Issue 10: Alameda - Santa Cruz “Y”

Santa Cruz Ave/Alameda de las Pulgas - Safety Issues

Currently at Santa Cruz/Alameda “Y”

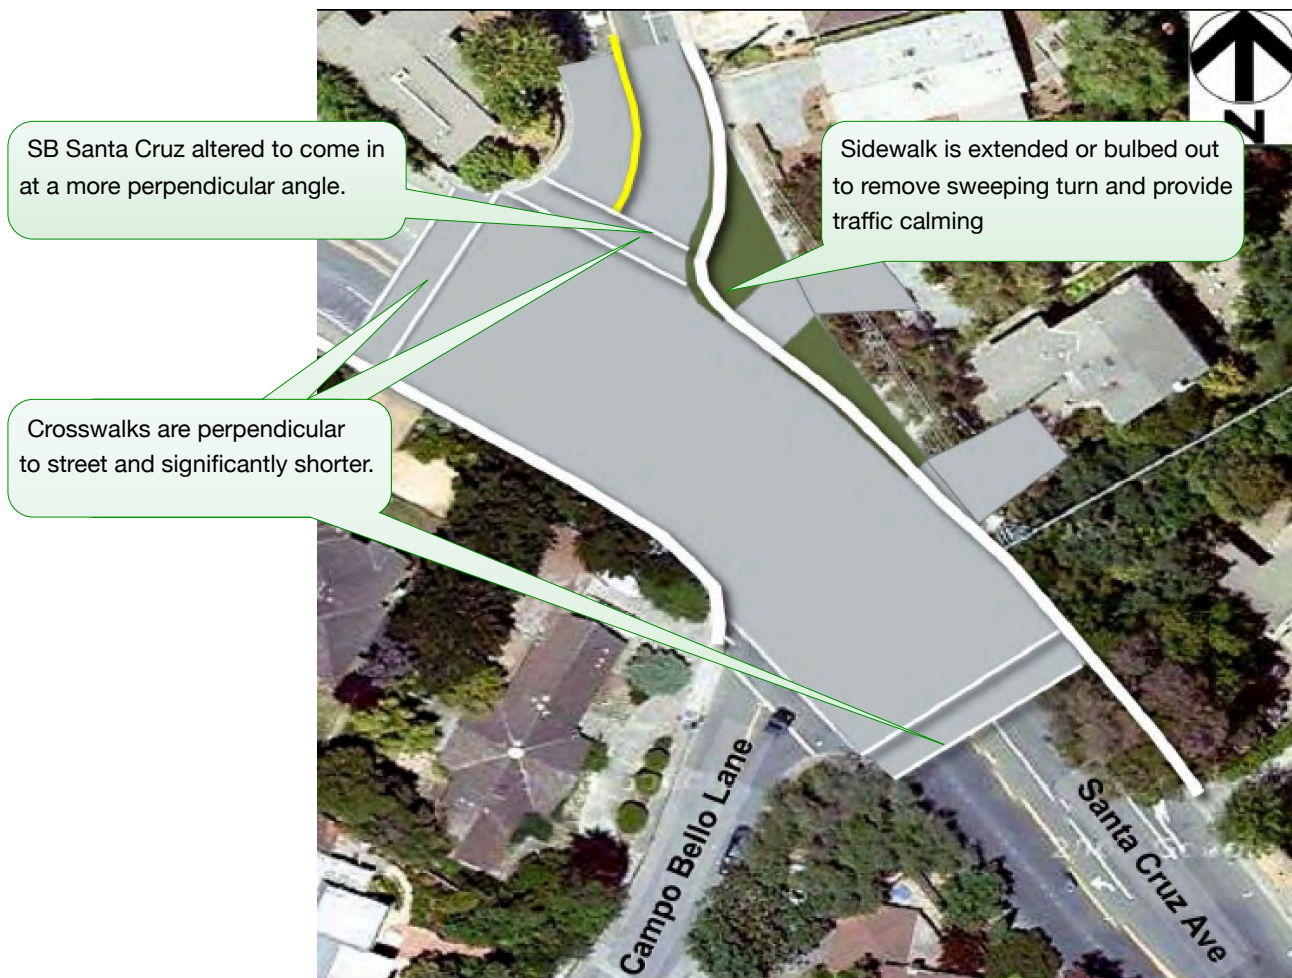
Blind Corner - Pedestrians and cars can't see each other. No traffic light crossing button.

Sidewalks are only 18" -24" and in disrepair - not ADA

Crosswalks at long angles,

No bike lanes nor any bike lane

Traffic / Light poles in middle of walkway - block access

Blind Corner - Pedestrians and cars can't see each other.

Curve has unsafe speed and is nearly always green with continuous traffic flow

The many traffic lights have confusing angles, not clear, timing issues, cause confusion

Unsafe Crosswalk, angle hides 2nd lane from view. No Stop limit line to keep cars back

Additional lane added as an “always green” lane NE bound.

Proposed Solution Option 10.2: Improved Berkeley Safety Assessment

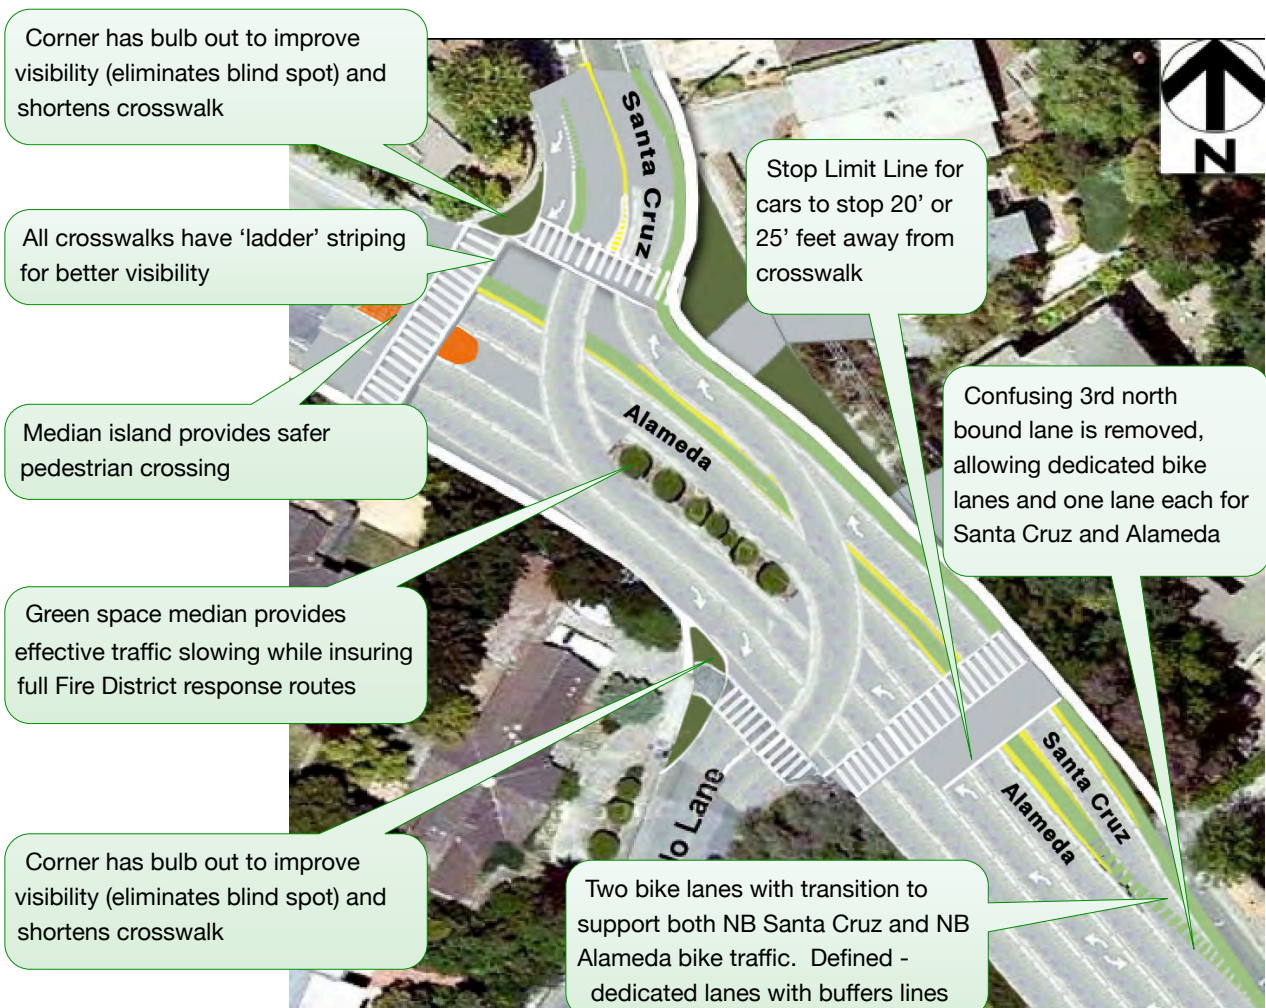
This **Option 10.2** proposed solution builds upon the Berkeley Pedestrian Safety Assessment (Solution Option 10.1). This is not the preferred solution (see 10.5) but it does have several key points:

- Adopts the suggestion of road consistency for Alameda (Issue #1), making it same as the rest of Alameda. These short 4 blocks would consist of bike lanes each direction, a center turn lane, and one lane of traffic each direction. This has the potential advantage of providing room for ADA compliant walkways.
- Creates bulb out at NE corner and the NW (at Campo Bello) to correct the blind corners and further shorten the crosswalks
- Retains good fire department access through Alameda and the “Y”
- Creates green median to provide support for slower traffic speeds
- both Campo Bello and Santa Cruz enter intersection at a more perpendicular approach
- Dedicated Bike lanes thru intersection for both NB Santa Cruz and NB Alameda

Note that traffic flow lanes are shown in the map to better understand traffic flow but are not meant to mean that these lines would be painted as such. This design work does NOT incorporate the road diets. The bike - traffic lane separation markings that provide an extra buffer between traffic and cyclists should be implemented.

Proposed Solution Option 10.3: Added Improvement to Berkeley Safety Assessment

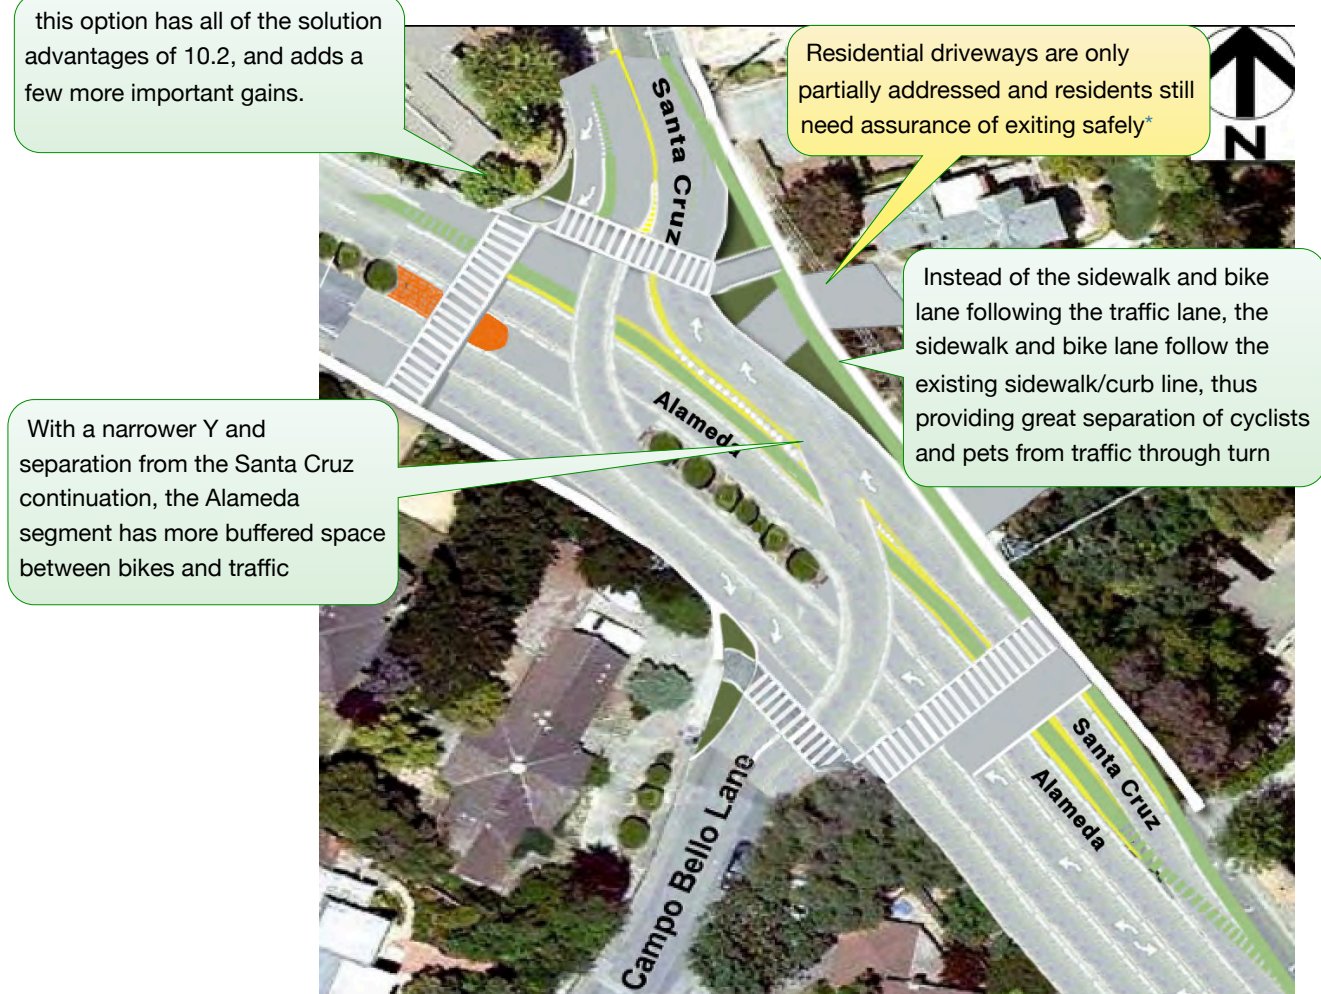
*While this and the prior options (Solution Options 10.1 and 10.2) greatly improve safety, and the safety issue of the residents along the Santa Cruz curve at the "Y" still need consideration, and so Safety Issue #5, Safe Egress - "Y" Residents, is still required.

This Solution **Option 10.3** builds upon the prior two solution options, keeping those improvements and adding one significant one: Moves the sidewalk to current sidewalk path and provides for the bike lane for this section to follow adjacent to the sidewalk instead of the traffic lane. **NOTE:** This design does not incorporate the Alameda and Santa Cruz Road diets — See Option 10.5.

Note that traffic flow lanes are shown in the map to better understand traffic flow but are not meant to mean that these lines would be painted as such. However, some form of bike lanes should be clearly marked as well as the suggested bike - traffic buffer separation markings that provide an extra space between traffic and cyclists.

Proposed Alameda Intersection at Y: This is the northern most crosswalk at the beginning of Alameda

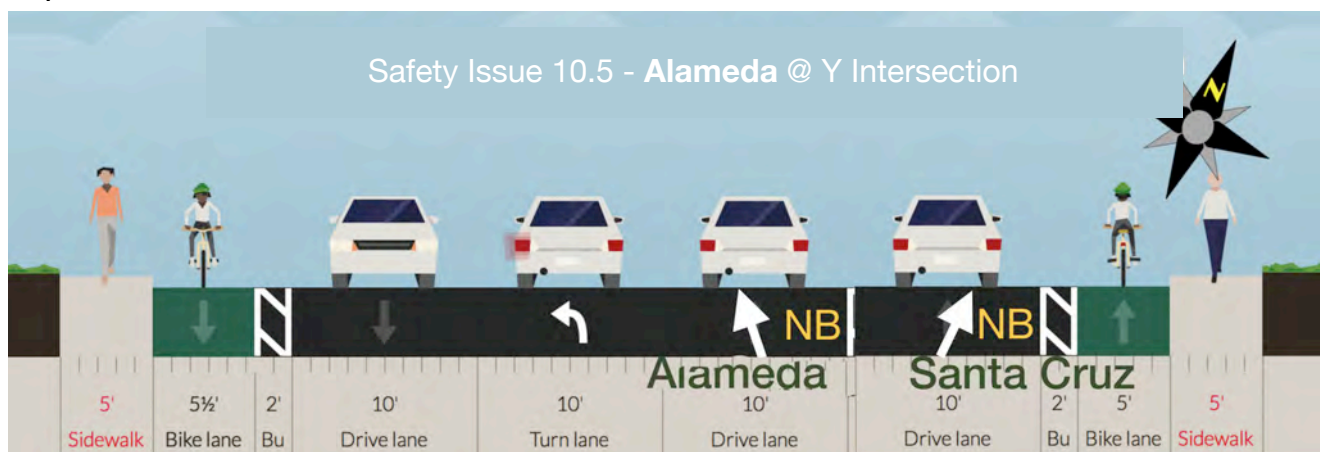
Current crosswalks are dangerous, unnecessarily long, and angled. They are not safe. This sub-section of this 10.5 solution explores details of the crosswalks for the Alameda and the south Santa Cruz sides.

- All Bike Lanes Buffered
- Reduced Lanes - 1 lane each direction
- Good separation for Pedestrians, Cyclists, and Cars
- Crosswalk width reduced by approx 50'
- Pedestrian safety median
- 5' Sidewalk at intersection
- Significantly reduces length of light signal
- Blind Corner on Santa Cruz eliminated
